IIoT Product Change Notice

The change will be applied on the ULI-211C (BB-FOSTCDR). If you need more information or special support, please contact the corresponding PMs/AEs listed in the table below.

2. Affected Products: ULI-211C (BB-FOSTCDR)

4. Description of the Change(s):

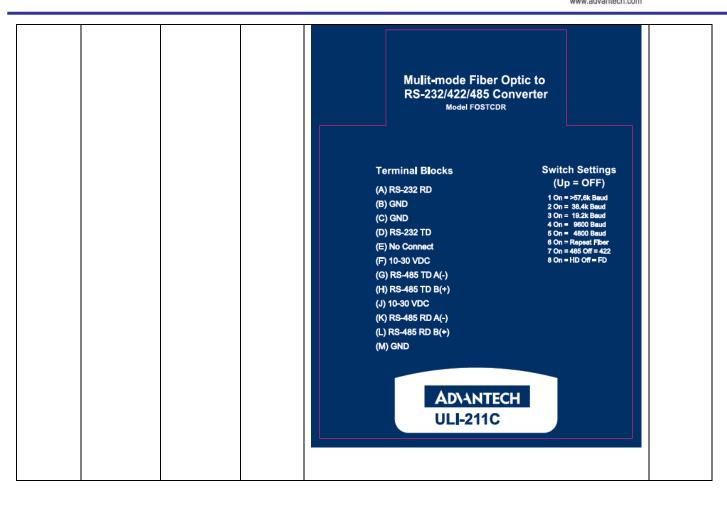
Affected	Current	New	Category	Outlook Difference	Reason
ULI-211C BB- FOSTCDR	20BB250- 10735-00	Component	Label	RS-232/RS-485	Branding
				New name plate

This device complies with Part 15 of the FCC Rules. Operation is subject to the following two conditions: (1) This device may not cause harmful interference, and (2) this device must accept any interference received, including interference that may cause undesired operation.	
ULI-211C BB-FOSTCDR	20BB9495	1990034427T010	Label	This device complies with Part 15 of the FCC Rules. Operation is subject to the following two conditions: (1) This device may not cause harmful interference, and (2) this device must accept any interference received, including interference that may cause undesired operation. CERSON USER CERSON	UL File Change
